City of Lakewood  
Board of Zoning Appeals

MINUTES  
BOARD OF ZONING APPEALS  
REVIEW MEETING  
LAKEWOOD CITY HALL  
DECEMBER 18, 2025  
6:30 P.M.  
RECORDING AVAILABLE

### 3. Docket No. 12-23-25 1321 Bunts Rd..

## Docket No. 12-23-25

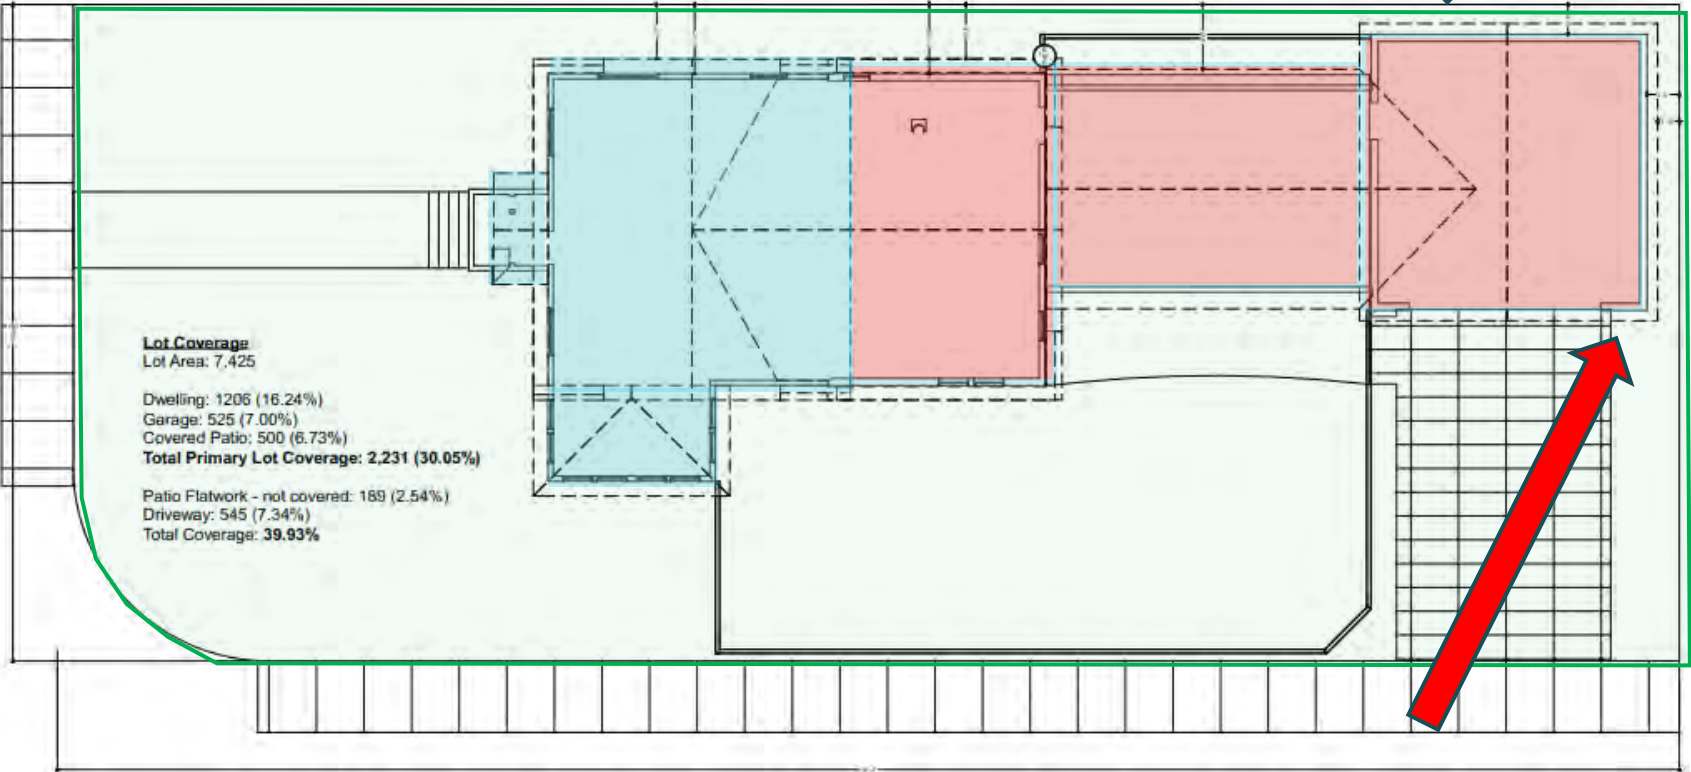
Var #1 - No longer required - plans updated  
show max lot coverage compliance

2'6" Proposed side setback

2'9" Proposed rear setback

Map with approx. Setbacks 1321 Bunts

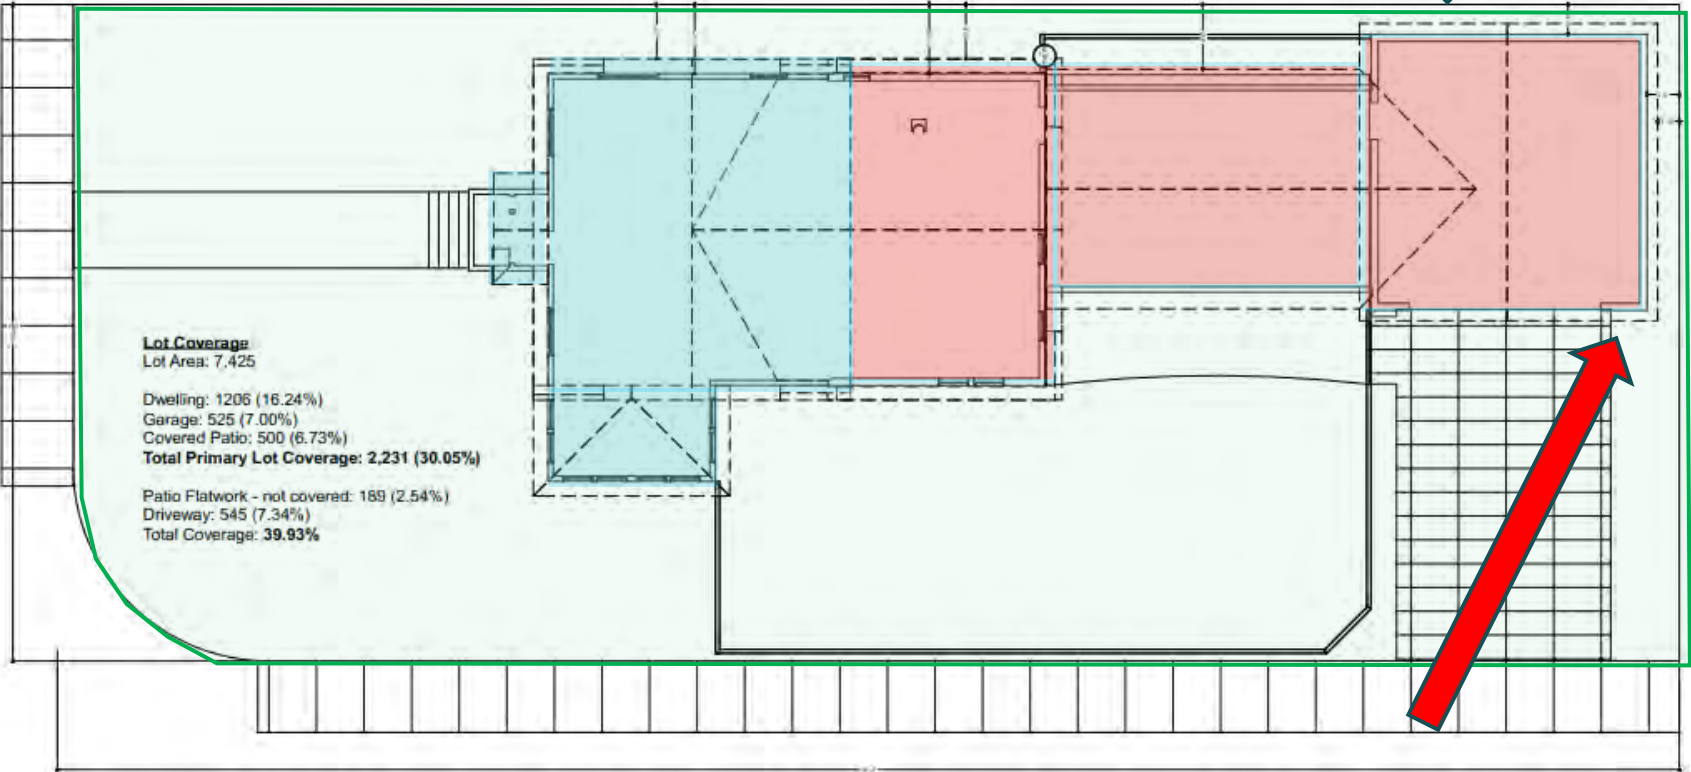
- The design documents have been approved by ABR.
- The house is on a corner lot, looking at 11 other corner lots along the north side of Merl between Manor Park and Jackson Merl, all are compliant with the 40-foot required rear setback, the average rear setback is 48 feet.

- The side setbacks of those same houses due to the limitations of the software and the smaller size of the side yards it is not possible to accurately estimate, they all appear to be around the 5-foot setback parameter, but that is an estimate that could be +/- 5.

- The building code has specific regulations related to fire codes for primary structures less than 3 feet from the property line. If approved this and all building code concerns will be addressed through the building plan review process.

- The request(38 feet) to both reduce the rear setback to less than 2 feet from the required 40 feet is a large request.
- Without the attached covered patio the rear yard would be approx. 54 feet x 56 feet= 3,024 sq ft, permitted rear lot coverage would be approx. 756 sq feet. The proposal is for a 500 square foot covered patio and a 525 square foot garage, if detached would still require a variance unless reduced to total 756 sq ft.

Fence proposed at 32 feet from PROW

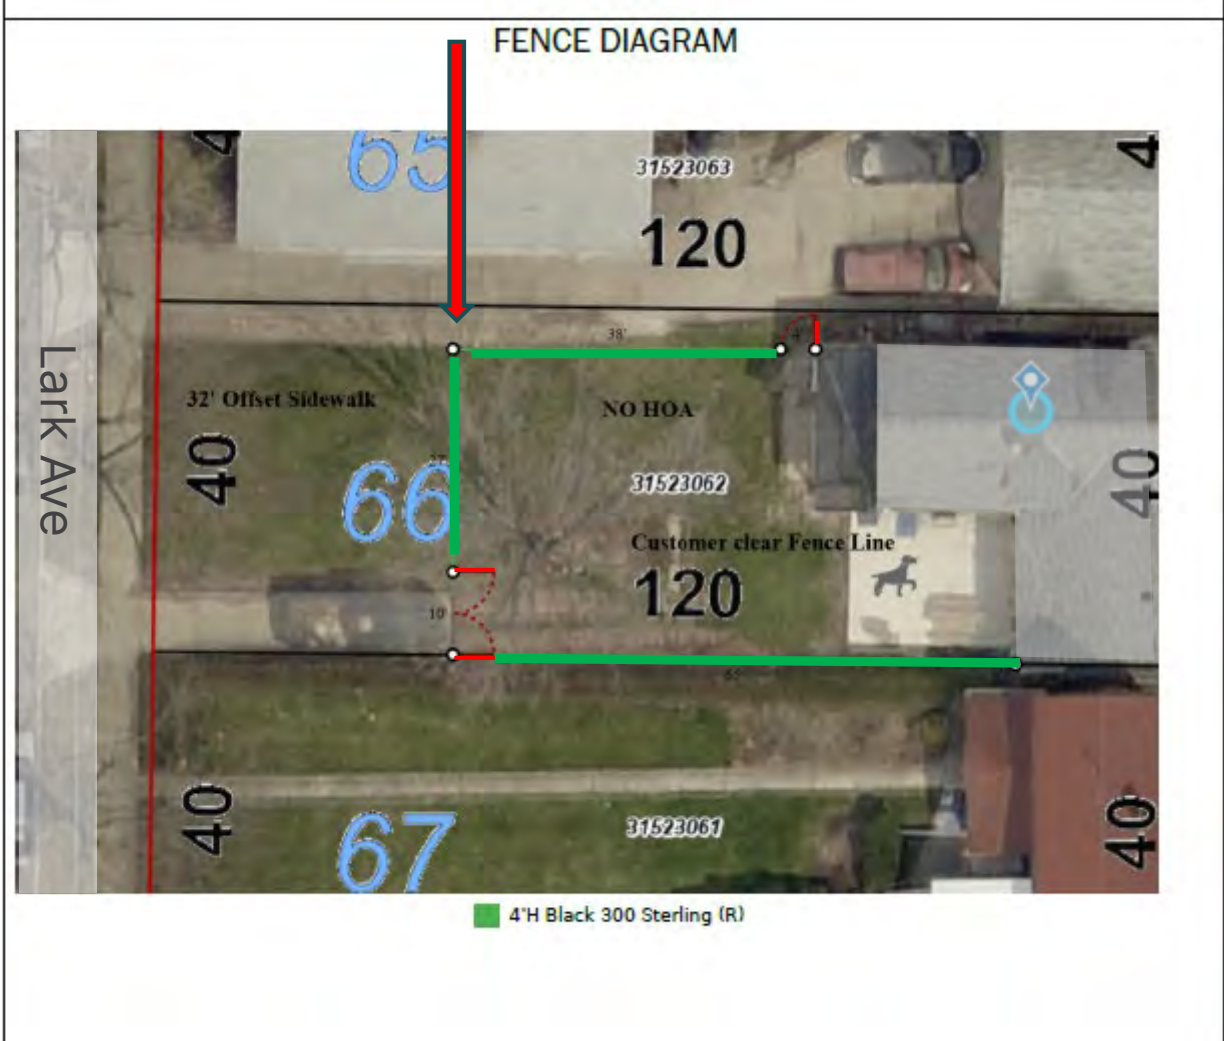
Home is set approx. 78 feet from the front property line on a 120-foot-deep lot. **The proposed fence is 32 feet from the public right of way, comprised of approx. 130 feet of 4-foot-high black aluminum fencing including 2 gates, a 10' wide driveway gate and a 4-foot-wide pedestrian gate.**

**Request a variance to permit the fence and gates in front of the foundation of the primary structure, as proposed.** Pursuant to 1153.03 FENCE PLACEMENT AND TYPES(c) Front Yards, (Ord. 08-2021, Passed 5-17-21)

- The house is located 78 feet from right of way on a 120 deep lot, there is no usable rear yard.
- Generally speaking, a home located at the rear of the lot is uncommon in Lakewood. The property adjacent to the subject property to the south at 2081 Lark is also setback at the rear of the lot. The property at 2081 Lark has an existing living fence enclosing the front yard.
- The proposed fence is behind the front building line which is 15 feet on Lark.
- The proposed fence is black aluminum
- The proposed fence and gate height is 4 feet

**site plan**

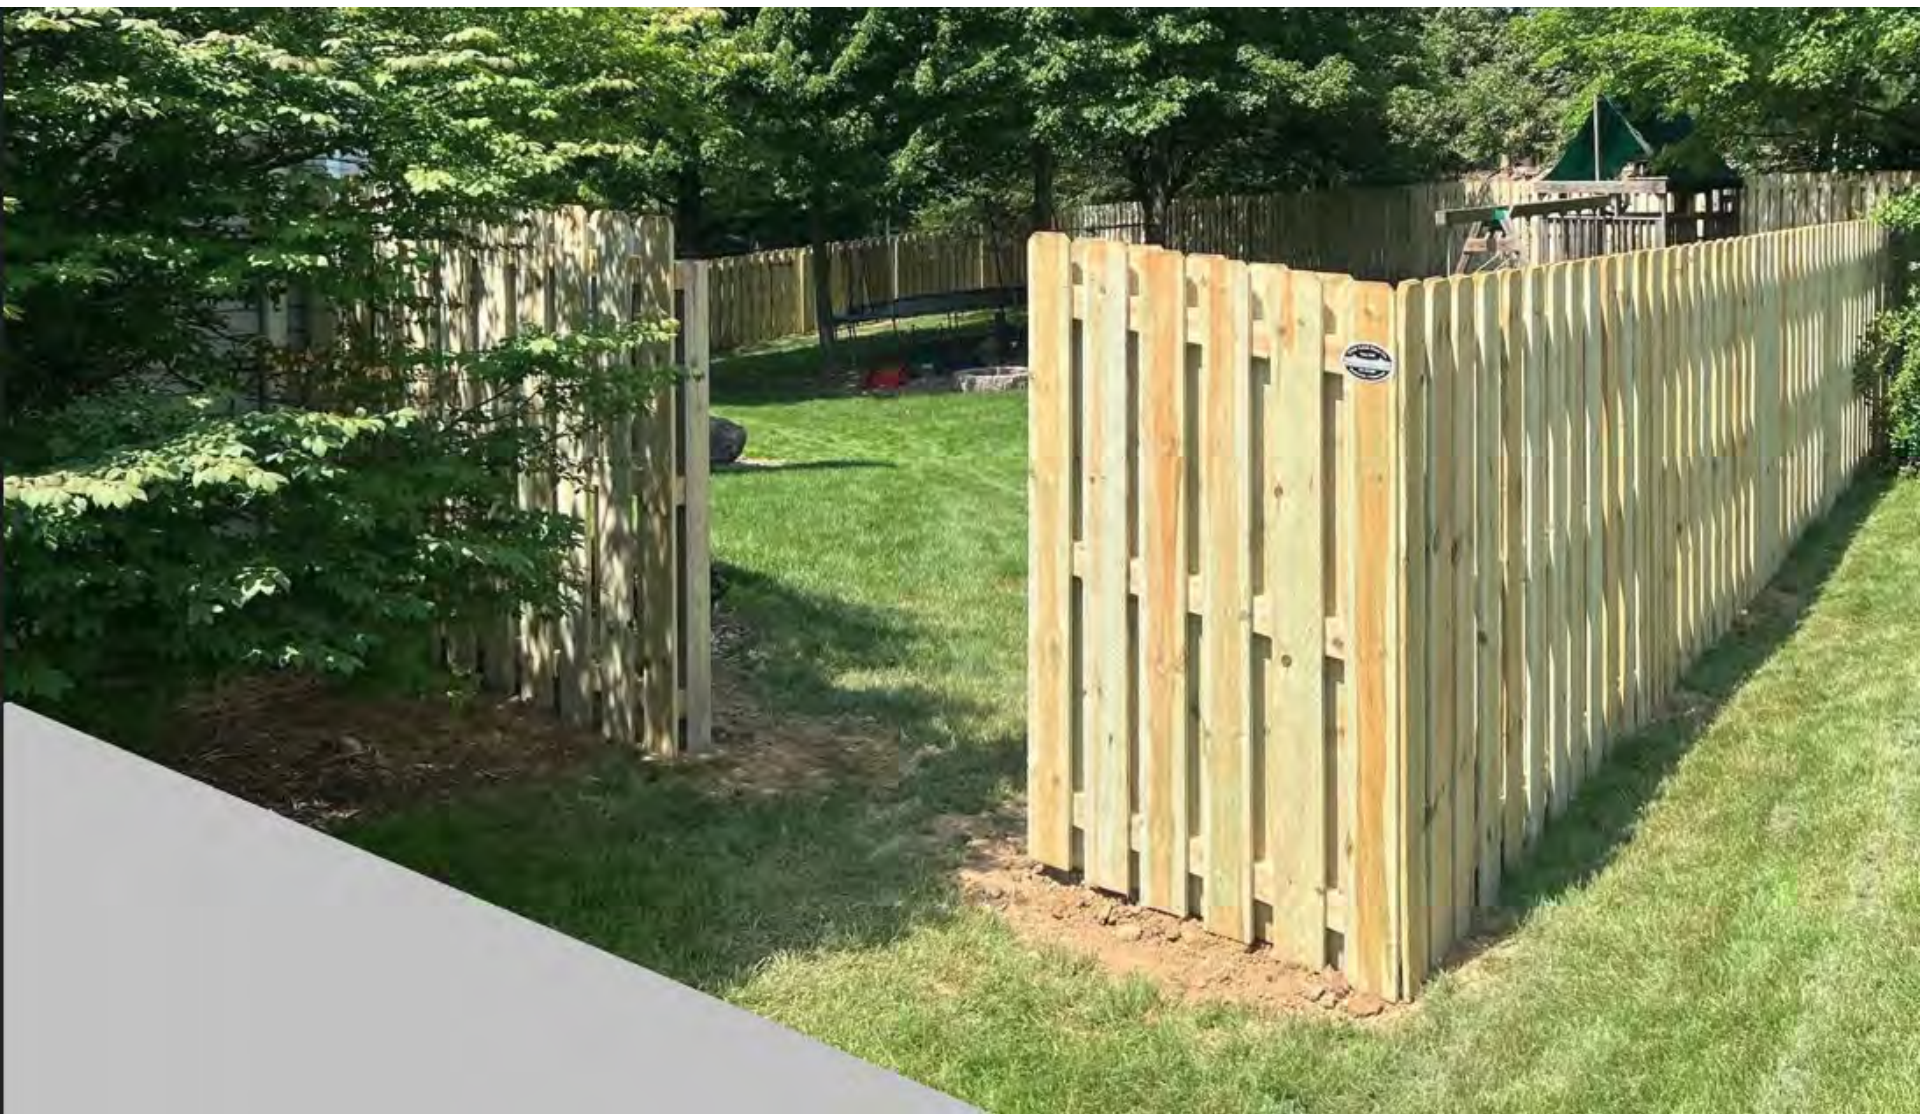
The building commissioner has begun the process of assigning an address, it will 1337 Edanola. I have a few more questions for you.

- Approximately how many feet of fence will be installed? - **Approximately 100' of fence. 30 +/- along Edanola, 50 +/- along Riverside, 20 +/- parallel with driveway.**
- Send an image of the fence and confirm the finished height will be 4 feet. - **Variance request is for privacy fence 72" high, with consideration what is permitted in a side yard height. While this is a corner lot, the intersection is distant and projected out further from corner of fence than a typical 90-degree junction of streets. Material not yet decided, wood or vinyl.**
- Number of gates and their locations - **One gate approximately 6' to 8' off house, facing driveway. Noted with an X on attachment.**
- Image of gate with height. Note- gates may not swing out over sidewalk. - **Gate 72" high to match fence.**
- Site photos - **Sent in separate email.**

- The existing driveway at the rear of the property reduces the usable rear yard of the property.
- The city has no record of a house having been on this lot before, although it has existed as a parcel.
- The front setback is maintained and the side setbacks for the primary structure are maintained with the proposal.
- If the garage were detached the proposal would not require a variance.
- The board has granted variances in the past to permit attached garages.
- The board has granted variances in the past to permit a fence closer to the sidewalk on a corner lot so long as it doesn't create a visual obstruction for traffic and pedestrians.
- The design will need ABR approval.
